TO: Scot Fakler, Project Manager
FROM: Gary Albrecht
DATE: September 11, 2014
SUBJECT: NE 94th Avenue – NE Padden Parkway to NE 99th Street, CRP #350822

On July 22, 2014, the Bicycle and Pedestrian Advisory Committee had an opportunity to provide input on a 50% preliminary plan set for NE 94th Avenue, CRP #305822. The committee has the following comments.

Figure 14-11. Shared-use paths should be designed with a minimum tread width of 3.05 m (10 ft) with graded areas of at least 610 mm (2 ft) on either side of the path.

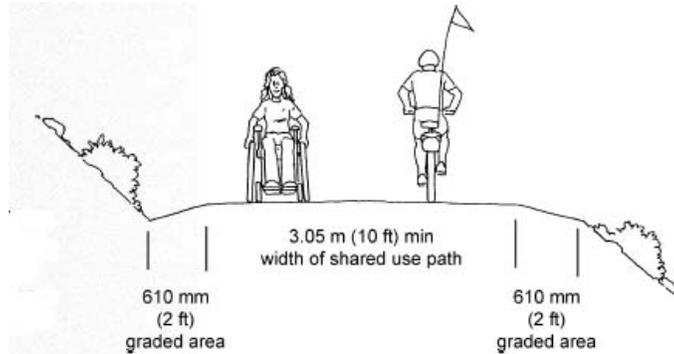
1. The committee is requesting the 8' sidewalk on the east side of the road to be a minimum width of 10' for a multi-use path. Below are the standards from the Federal Highway Administration Designing Sidewalks and Trails for Access Part II of II: Best Practices Design Guide (updated 2/10/2014) for a shared-use path width.

The tread of a shared-use path should be at least 3.05 m (10 ft) wide. A minimum of 2.44 m (8 ft) may be used on shared-use paths that will have limited use. Shared-use paths should also have graded areas at least 610 mm (2 ft) on either side of the path. On shared-use paths with heavy volumes of users, tread width should be increased to a range from 3.66 m to 4.27 m (12 ft to 14 ft).
